DESIGN EXCELLENCE COMPETITION JURY REPORT

City of Parramatta

Phase 2 Competition for Architectural Design
Block H, Precinct B, Wentworth Point
21 November, 2019

Image: FJMT response to Jury revised 54k and 85k tower forms

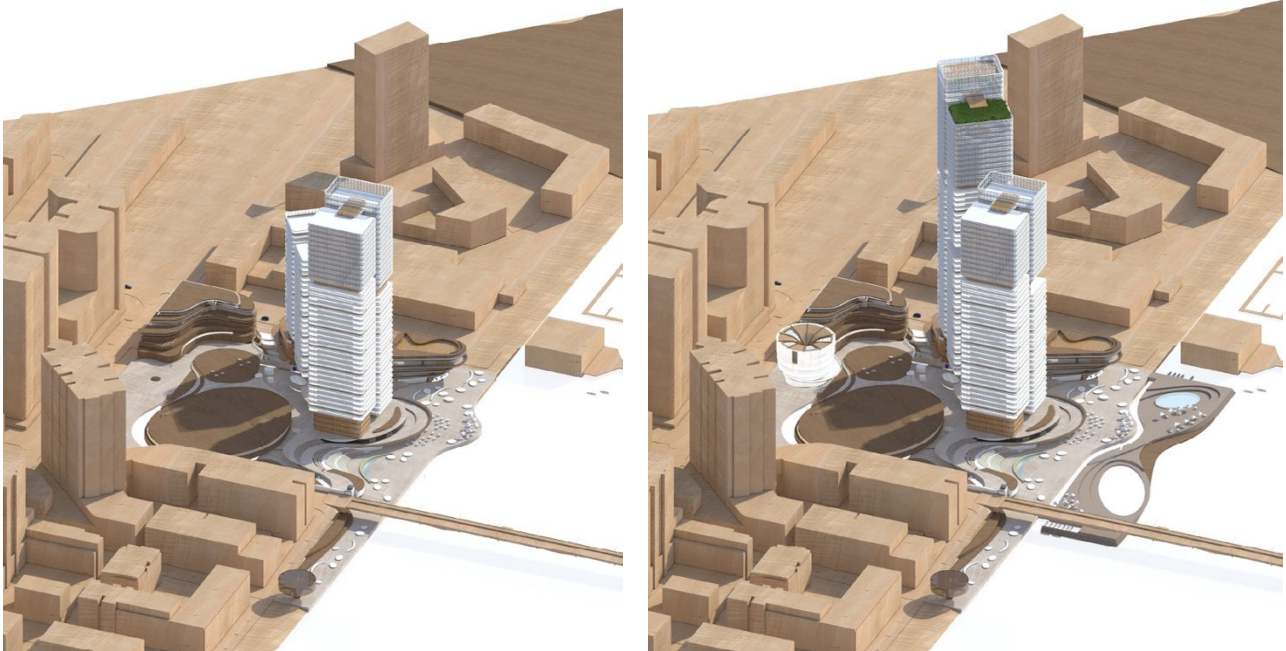
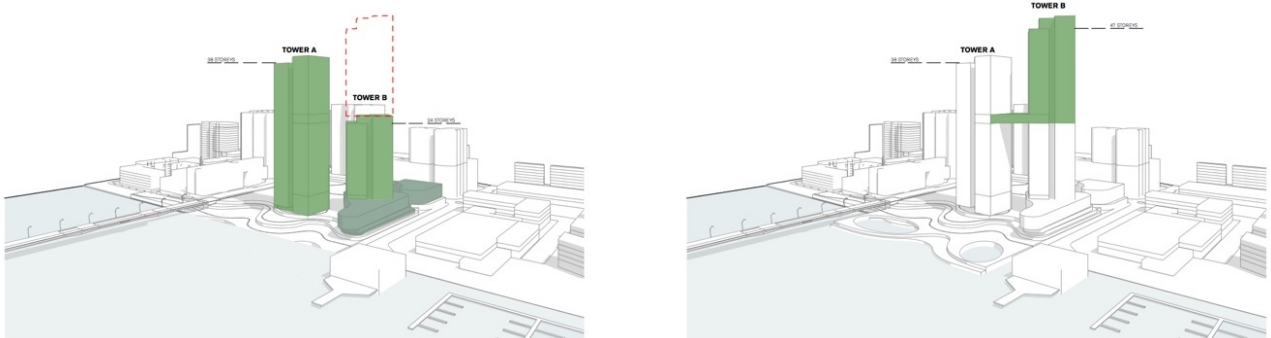
In responding to the Jury's preliminary comments, the design of the towers has been revised with altered orientations and approaches to articulation to reduce the perception of overall mass as well as introducing vehicle access into the park to the towers and replanning the foreshore building lines.

- Tower - location and orientation – The Jury are supportive of the approach to tower placement that ensures view sharing to adjacent developments is respected. The revised approach to tower rotation/orientation is also supported.

- Tower Façade – The revised façade treatments submitted as part of the response to Jury comments is strongly supported by the Jury, and should be retained at DA stage. This includes the provision of 500mm deep horizontal shading at various heights and increased solid spandrels.

Draft plan extract showing revised low level floor plates with improved ADG compliance (FJMT)

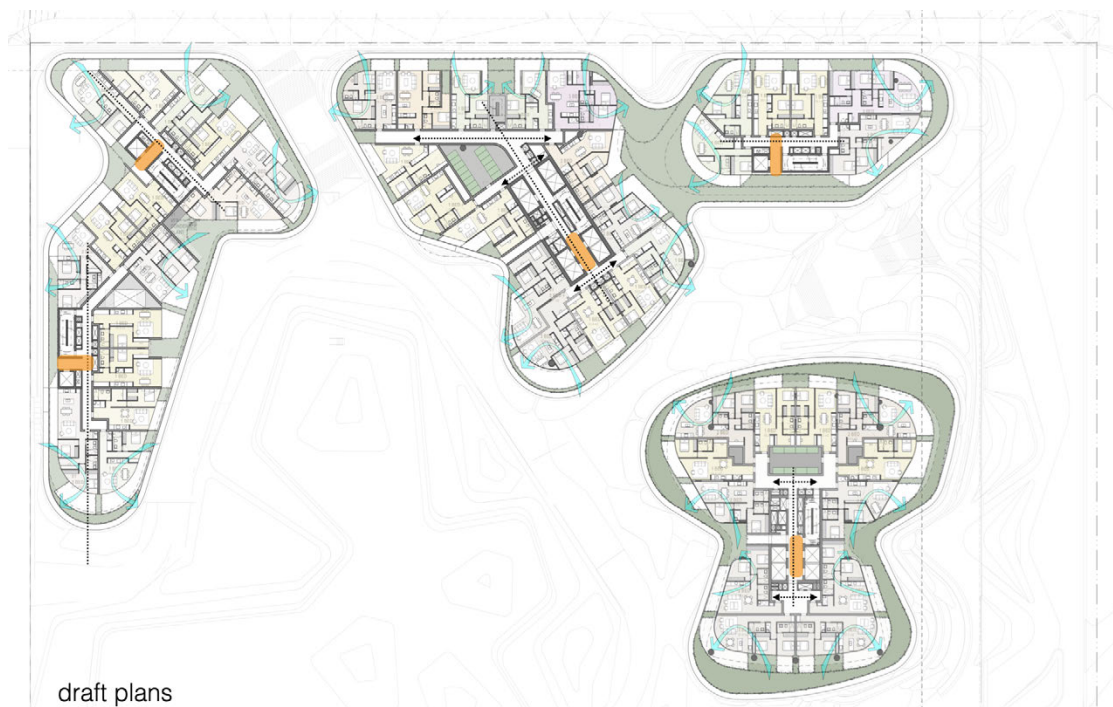
- The Jury are concerned that some key requirements of the ADG are not being achieved – including solar access and natural cross ventilation.
- In order to achieve Design Excellence, the Jury require that full compliance with the ADG is achieved. This requirement is considered acceptable based on the unconstrained size of this site, and the fact the design has been the product of a Design Excellence Master Plan Competition.

- The Jury requested that Council's independent ESD advisor review and comment on the draft submission.
- The key items that require design development are:
 - Natural Cross Ventilation remains unresolved and it is not clear how the ADG requirements will be met,
 - Adequate ventilation of enclosed balconies, and
 - Significantly challenged in achieving solar access compliance, particularly Tower A.

- Minimum ADG solar access and natural cross ventilation are achieved in the refined schemes, which are anticipated to achieve full Guide compliance.
- A more regular, “calmer” podium, has been reintroduced for a better urban outcome on Burroway Road and has been broken into three separate buildings to improve ADG environmental and amenity performance.
- A more measured exuberance is reflected in the schemes. The achievement of amenity, privacy, solar access and ADG compliance aspects of the “butterfly form” tower floorplates have been thoroughly considered and demonstrated in the revised schemes.

Extract showing soil depth provision (FJMT)

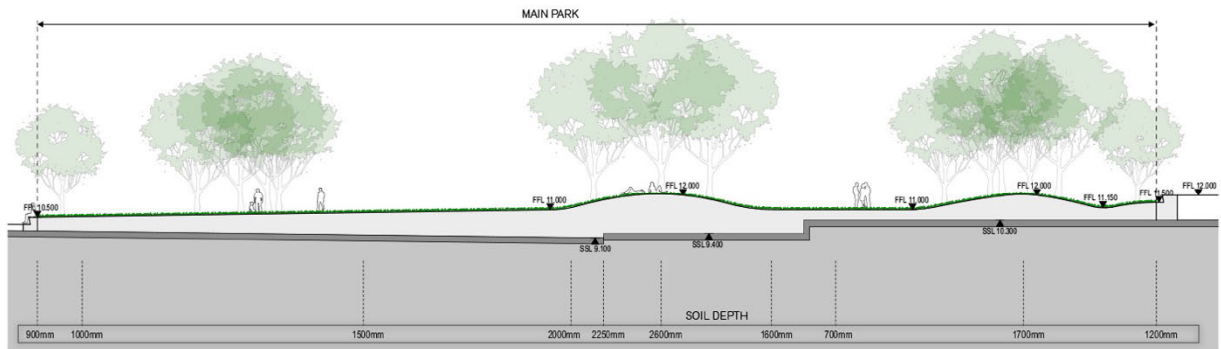
- The design development of the landscaping and shared way have been thoughtfully executed. The Jury are of the view that the landscape design is “heading in the right direction” and will be a positive outcome for the community .
- Council’s City Architect, on behalf of the Jury has requested that Council’s Public Domain team review the latest submission and attend all future Jury Presentations.
- The Jury would also like to better understand, in plan and section, how deep soil zones are achieved and the landscape vision is realised.

- Council’s Public Domain team will be closely engaged through to DA submission while the adequacy of the soil depth zones to achieve the landscape vision have been provided in plan and section as extracted below.

Diagram showing traffic movement onto the site (FJMT)

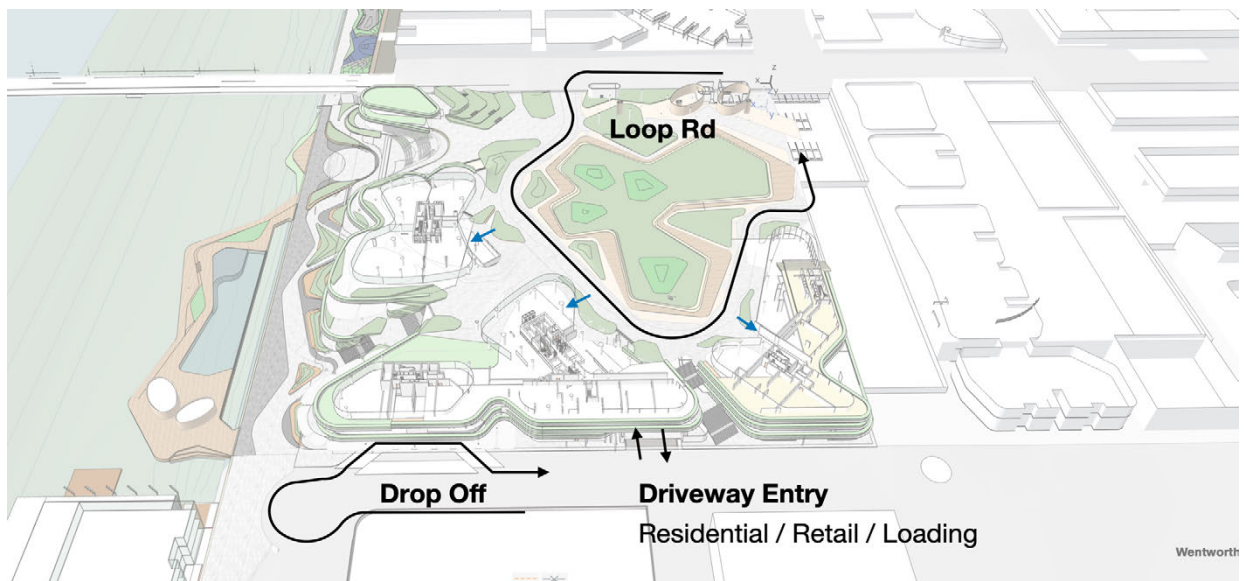
- The Jury would like to better understand how traffic works holistically across the site.
- The Jury question the removal of the “oculus” that provided light into the basement carparks. It is recommended that every effort is made to providing natural light and ventilation into the basement carparks.

- The “oculus” providing natural light and ventilation into the basement carparks has been re-established.
- Details as to how traffic works holistically across the site has been provided and summarised in the extract below.

FJMT - Improvement opportunities.

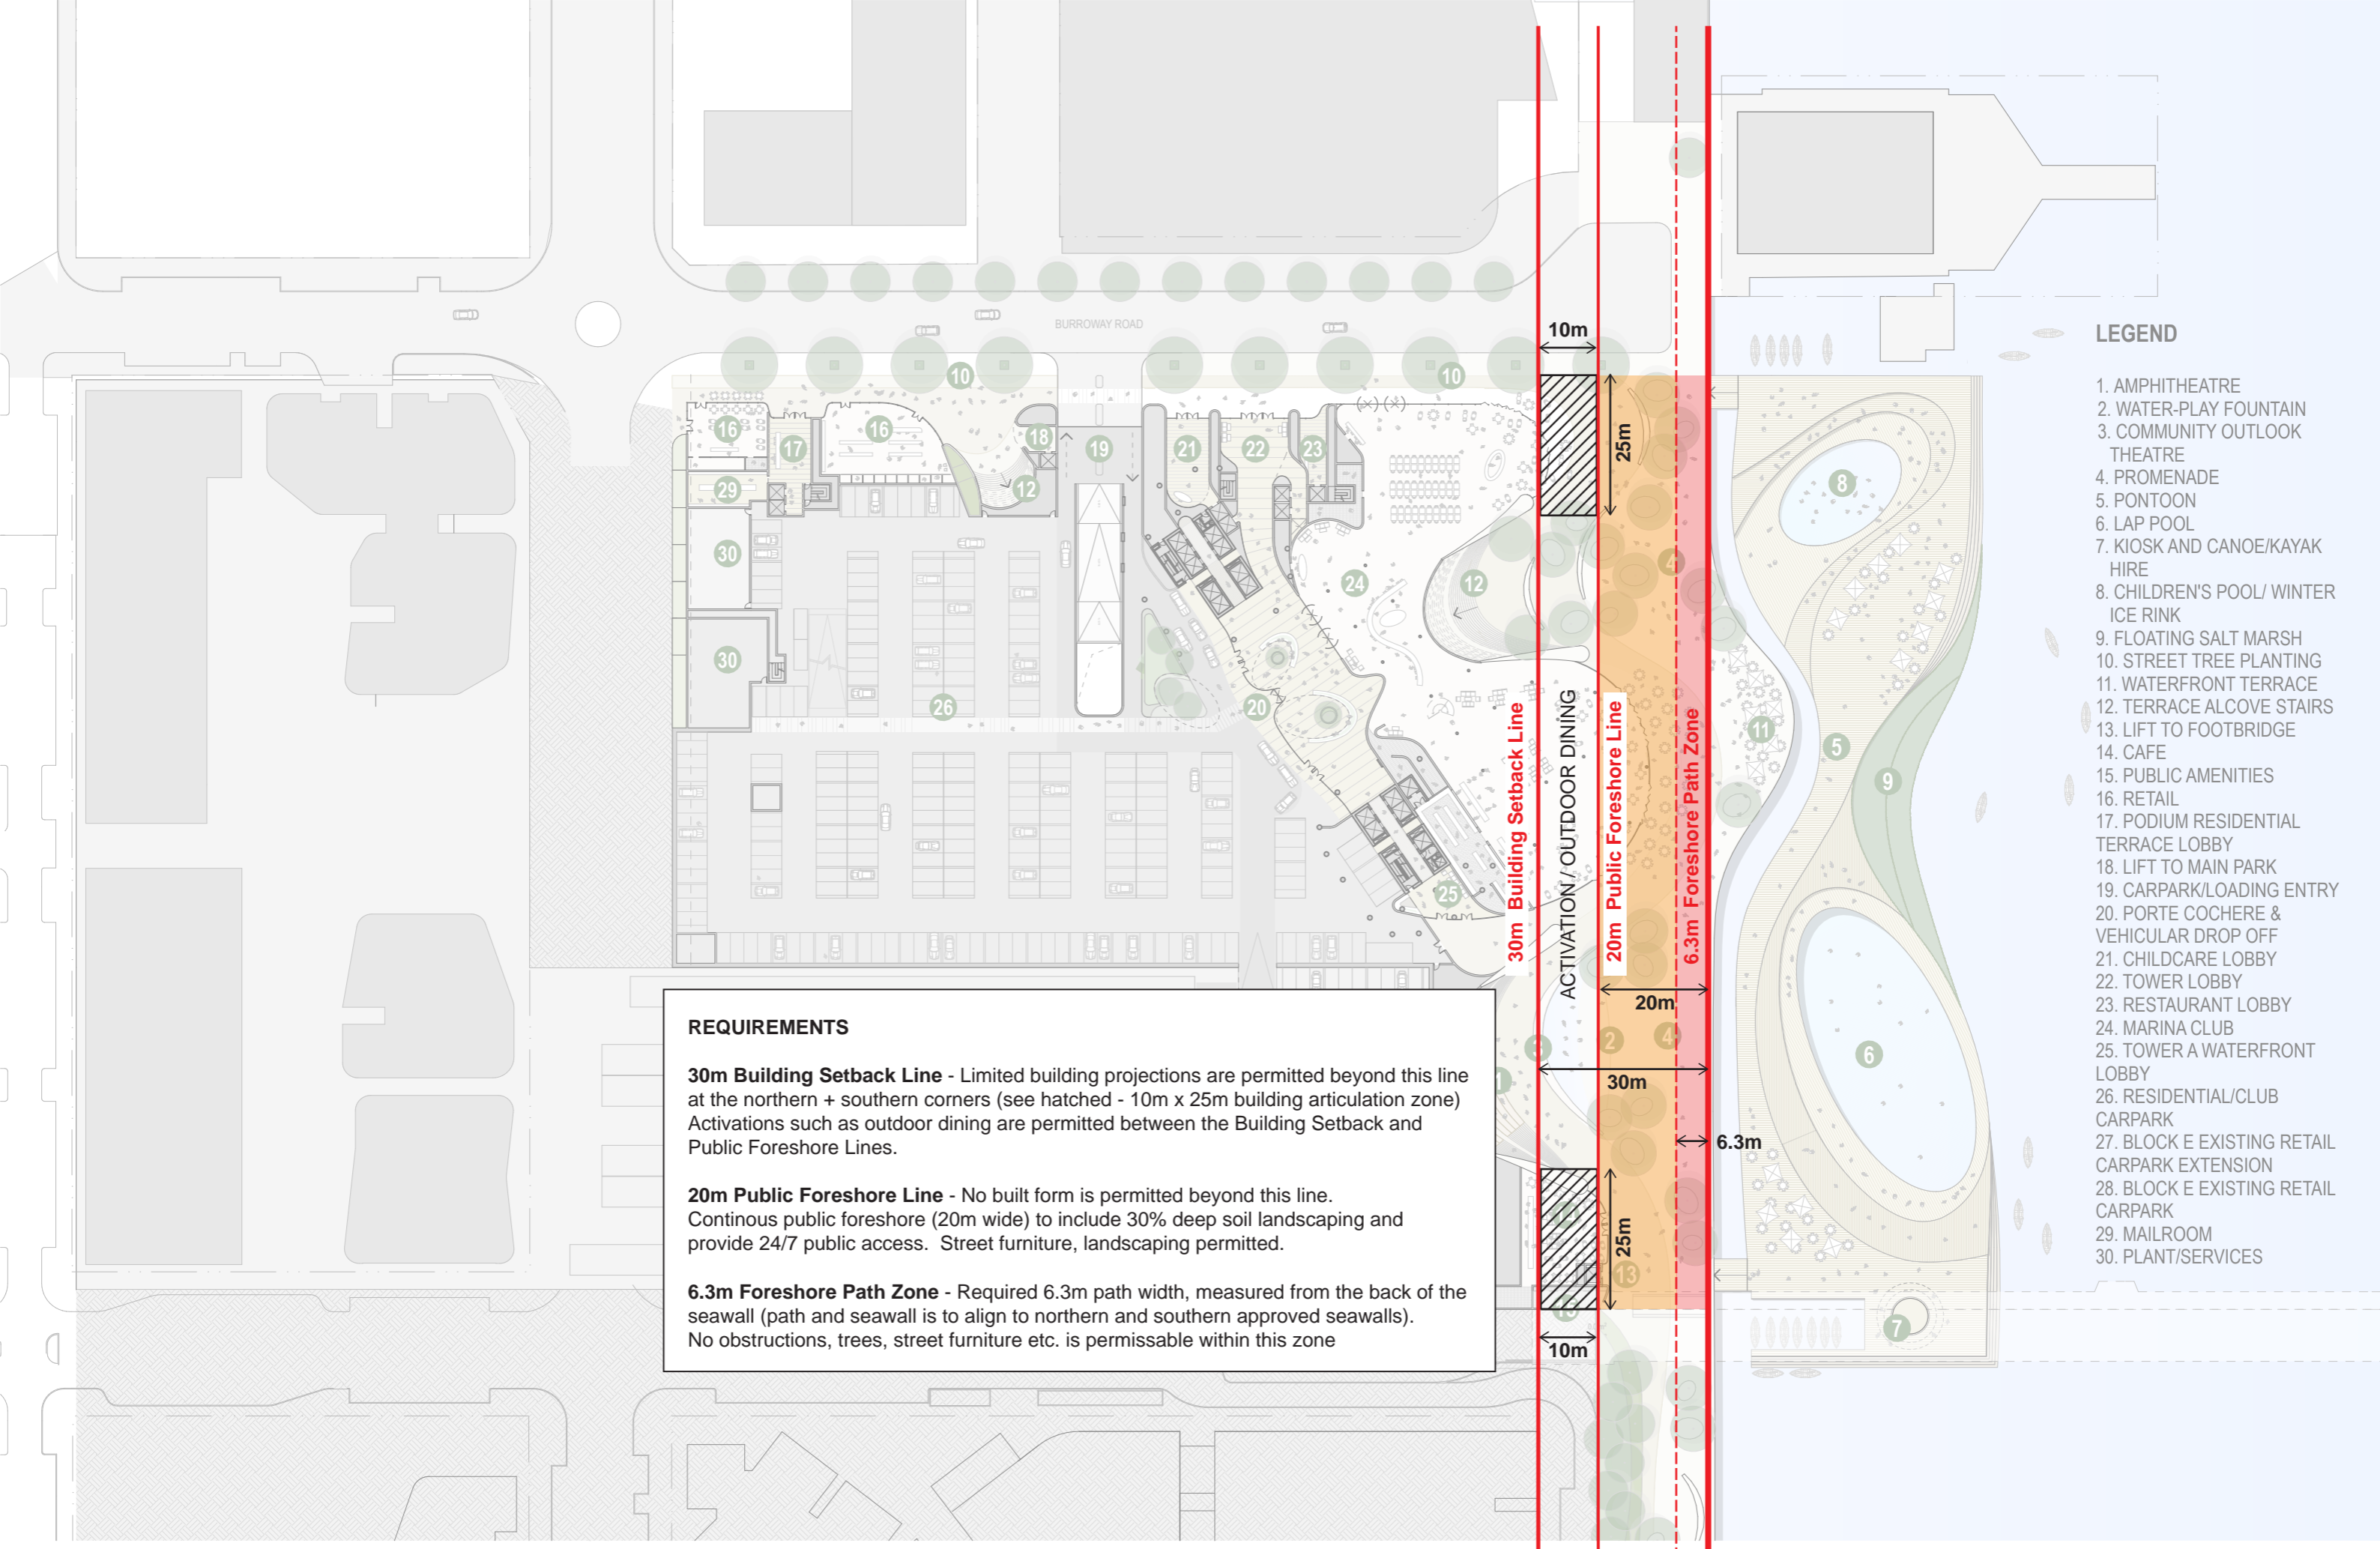
- Develop a solution for the facade that provides protection sun protection/minimises solar reflection.
- Introduce capture and reuse of stormwater
- If podium residential cannot be relocated, ensure chimneys are able to be coordinated above ground.
- Develop openings in ground plane to maximum benefit of natural air makeup to the car park.
- Cost allowance for Dual piping should be provided.

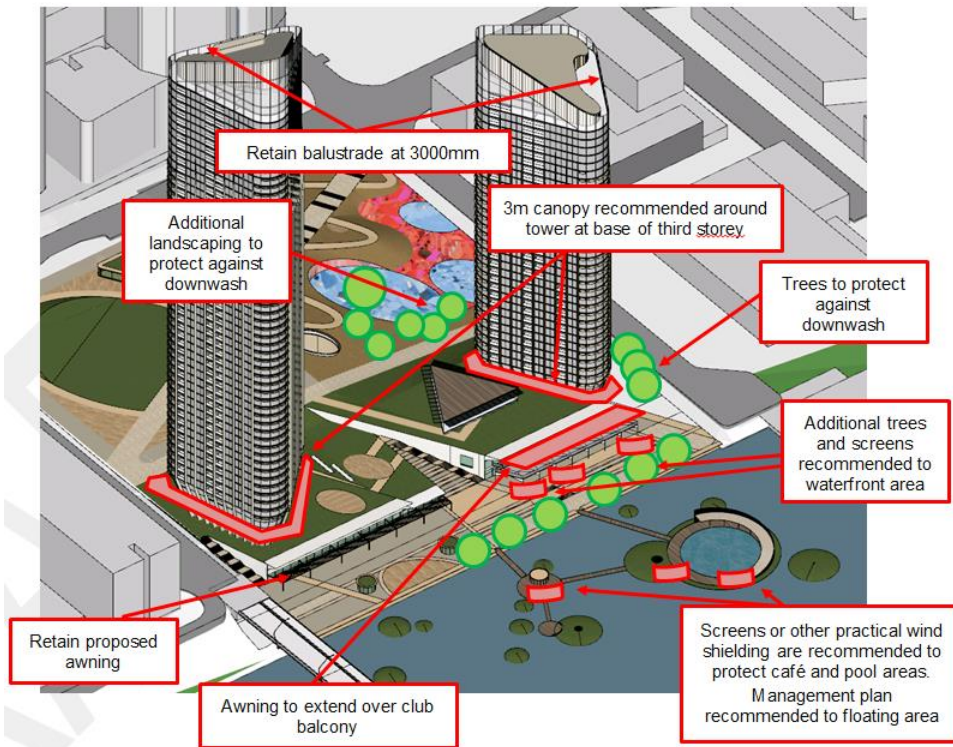
Waterfront Promenade: Landscaping and screens are recommended to protect seating and standing areas.

Floating Area: Screens or practical wind shielding is recommended to the area. A management plan regarding adverse winds and use of the public space is recommended to be applied to the floating area.

Club Balcony: Awning is recommended to be extended to protect seating and standing areas

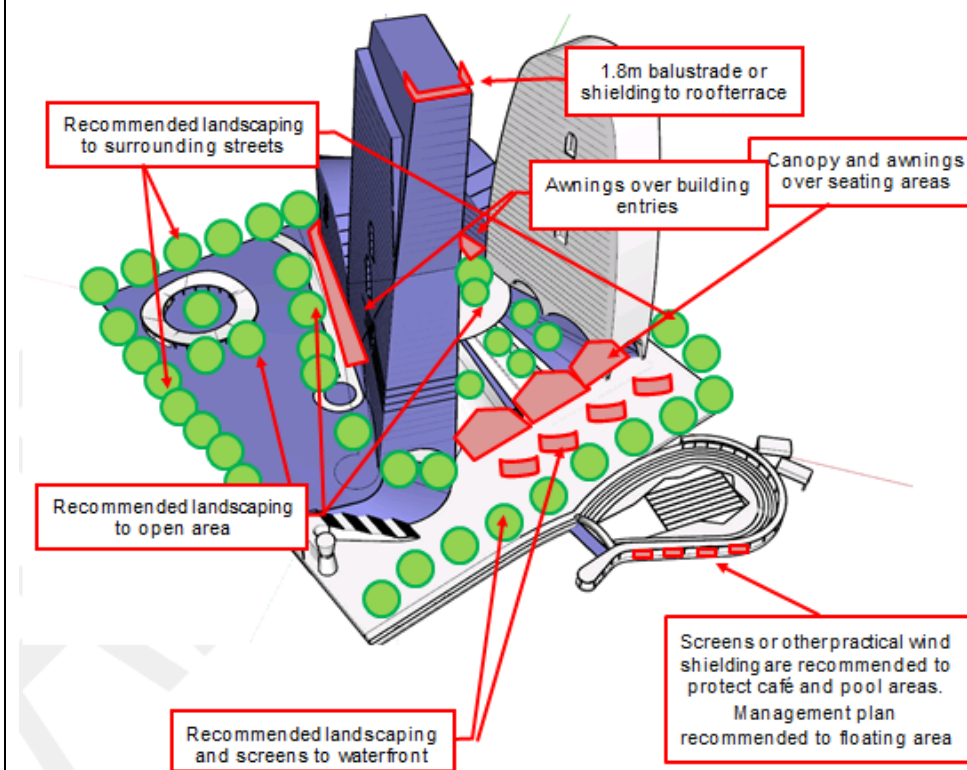
Surrounding Streets: Additional landscaping is recommended along surrounding streets to mitigate against wind channelling between buildings.

Floating Pool and Beach Area: Screens or practical wind shielding is recommended to the area. A management plan regarding adverse winds and use of the public space is recommended to be applied to the floating area.

Retail and Building Entries: Additional landscaping is recommended. Further awnings or canopies are recommended above building entries.

Open Park: Additional landscaping is recommended.

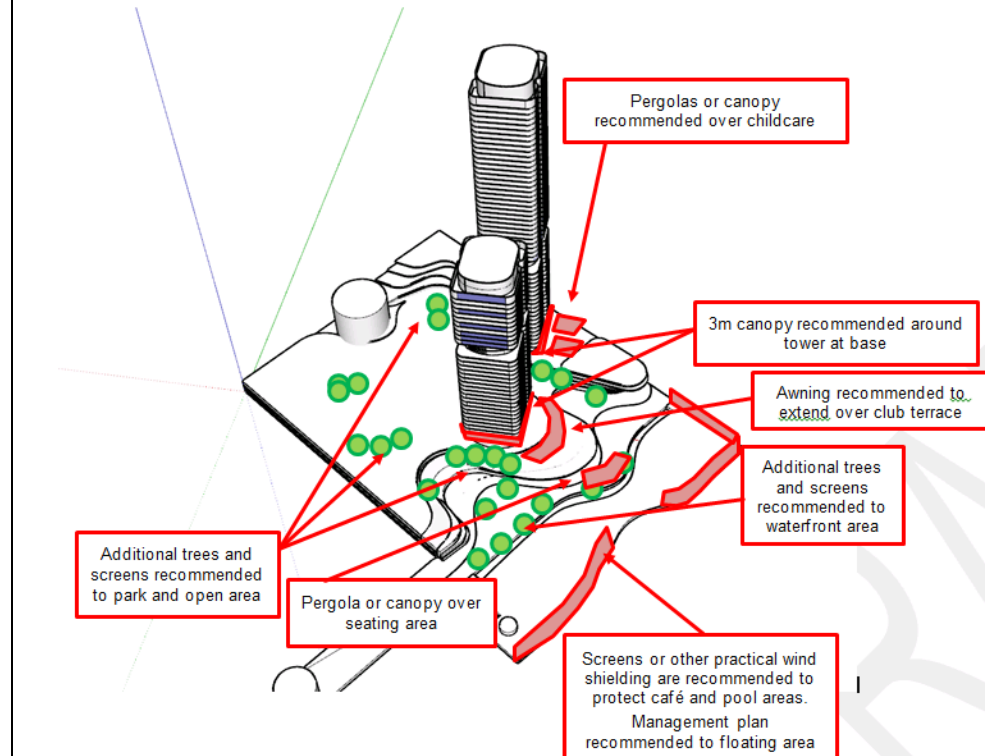
Waterfront Promenade: Landscaping and screens are recommended to protect seating and standing areas.

Floating Area: Screens or practical wind shielding is recommended to the area. A management plan regarding adverse winds and use of the public space is recommended to be applied to the floating area.

Club Terrace: Extend awning above or incorporate pergolas/ canopy to protect seating areas.

Tower Entries: A 3m canopy is Recommended to the surrounds of both towers to be applied as low as practically feasible. Alternatives to this could be assessed through quantitative testing during DA stage.
